SUBJECT: Forwards info supporting review of First & Second 10-yr ISI program plans. *See Reports*

Subject: **WNP-2, OPERATING LICENSE NPF-21  
SECOND 10-YEAR INSERVICE INSPECTION PROGRAM PLAN**

## FIRST INTERVAL ISI PROGRAM PLAN

## SECOND INTERVAL ISI PROGRAM PLAN

Figure 5-3 Remote TLDs

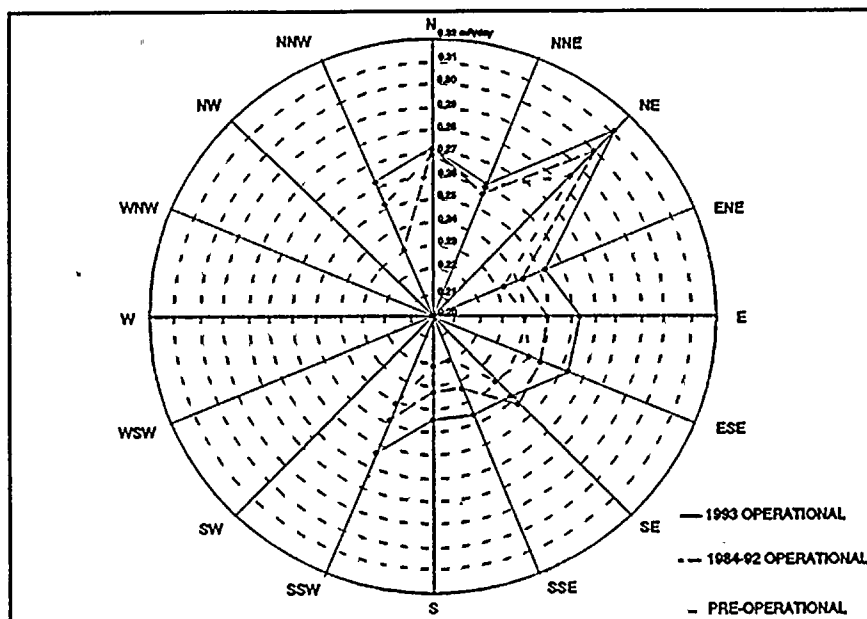
Page 5-3, Figure 5-3: Chart incorrect, correct chart shown.

Figure 5-12 Zn-65 in Discharge Water - 1993

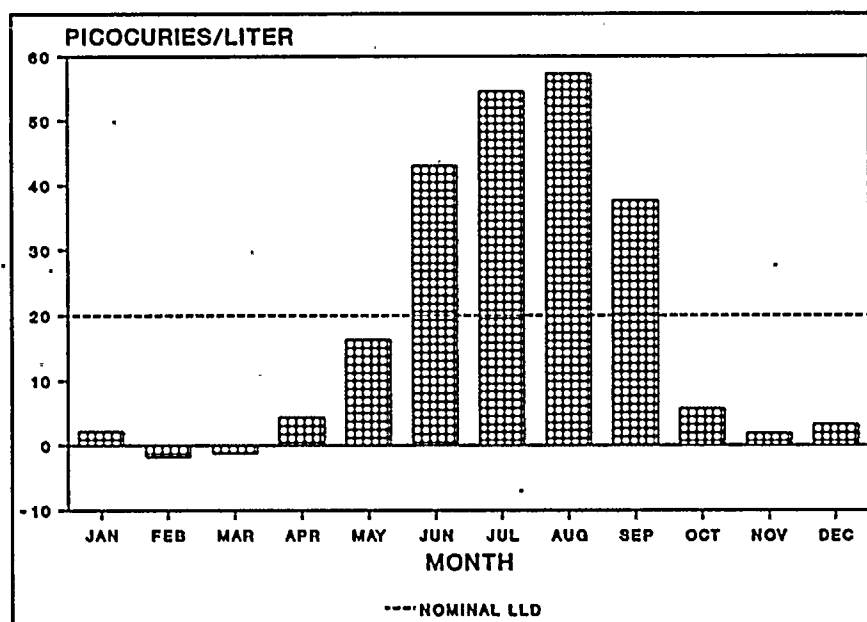
Page 5-6, Figure 5-12: Chart incorrect, correct chart shown.
